ARCHITECT'S SUPPLEMENTAL INSTRUCTIONS

Project:	Lumberyard District – Buildings 2, 6, 8 & 9 Omaha, NE	Initiated By		Distributed To	
Project Number:	15927	<input type="checkbox"/>	Owner	<input checked="" type="checkbox"/>	
Owner:	Lanoha Development	<input type="checkbox"/>	Architect	<input checked="" type="checkbox"/>	
To Contractor:	Overland Constructors 5036 South 135 th Street Omaha, NE 68145	<input type="checkbox"/>	Contractor	<input checked="" type="checkbox"/>	
		<input checked="" type="checkbox"/>	Consultant	<input checked="" type="checkbox"/>	
		<input type="checkbox"/>	Field	<input type="checkbox"/>	
		<input type="checkbox"/>	Other	<input type="checkbox"/>	
Supplemental Instruction No.:	004				
Date:	July 8, 2016				
Contract Date:	February 15, 2016				
Contract For:	New Construction				
By:	Holland Basham Architects

Description: Revise data locations and deck light fixtures in the units.

5 ENLARGED TYPICAL UNIT F1A - ELECTRICAL

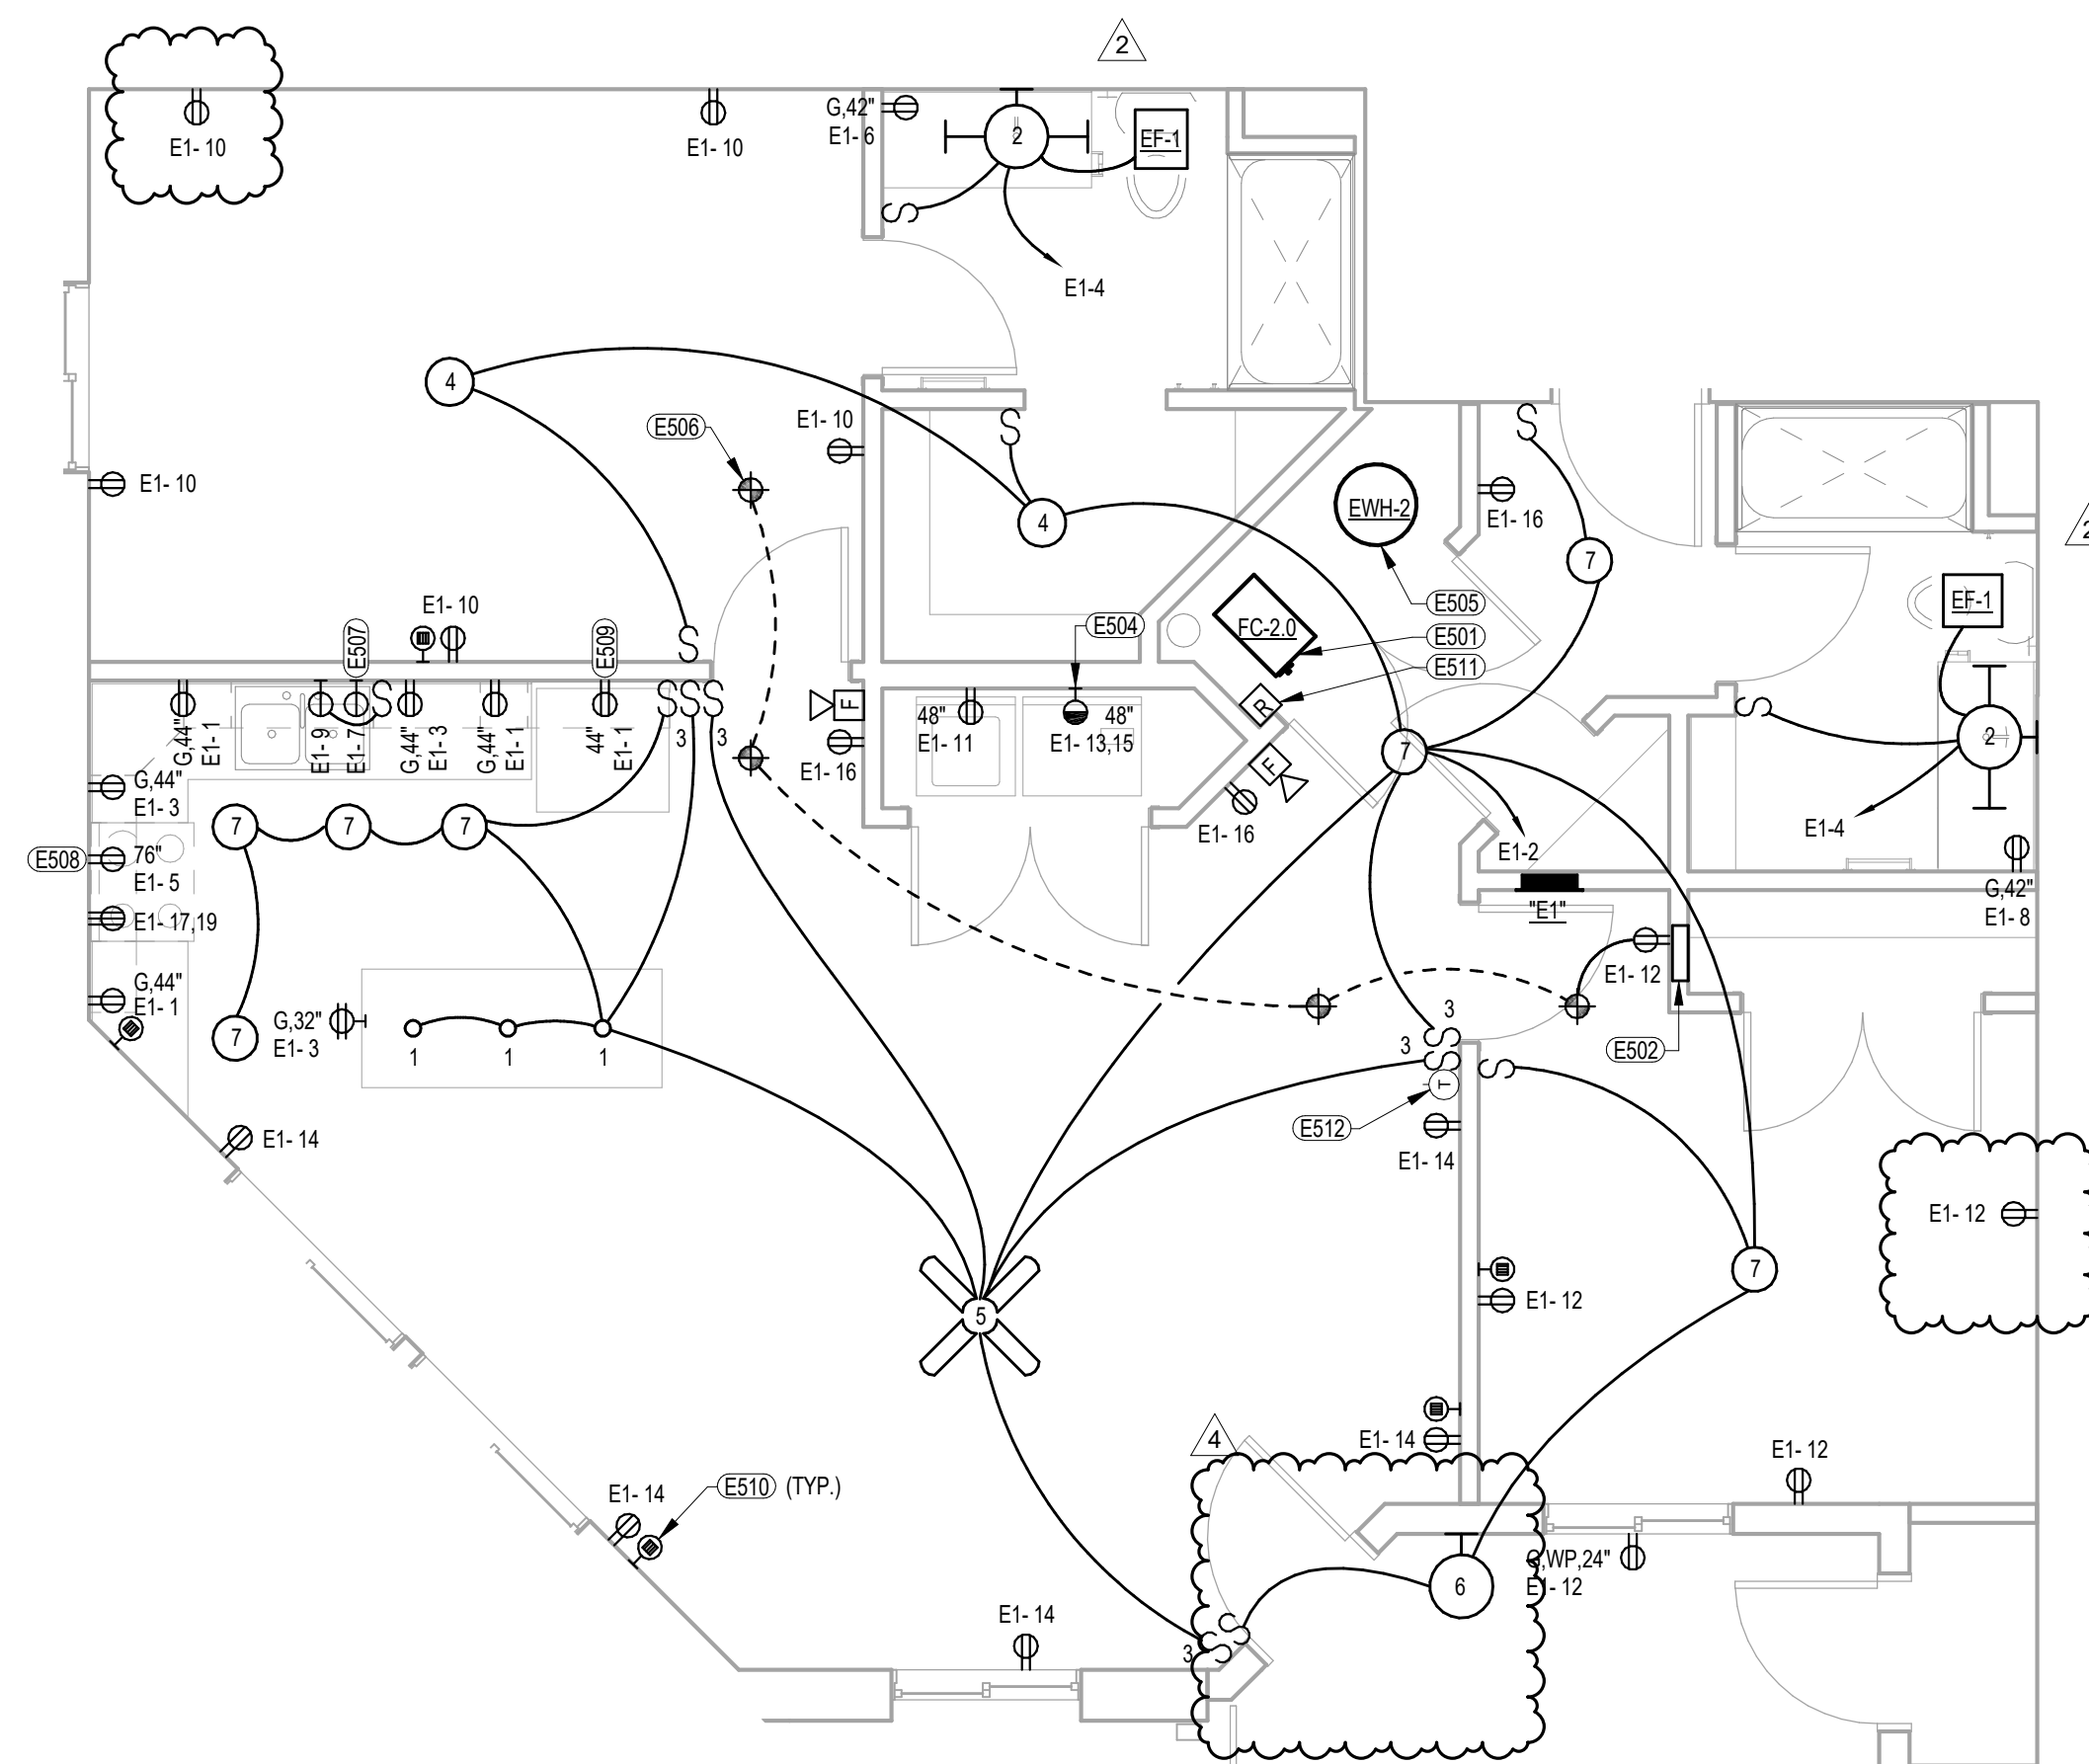
2. Sheet E6.02 – Enlarged Unit Plans - Electrical
 - a. Revise unit plans as shown in the attached Sheet E6.02.
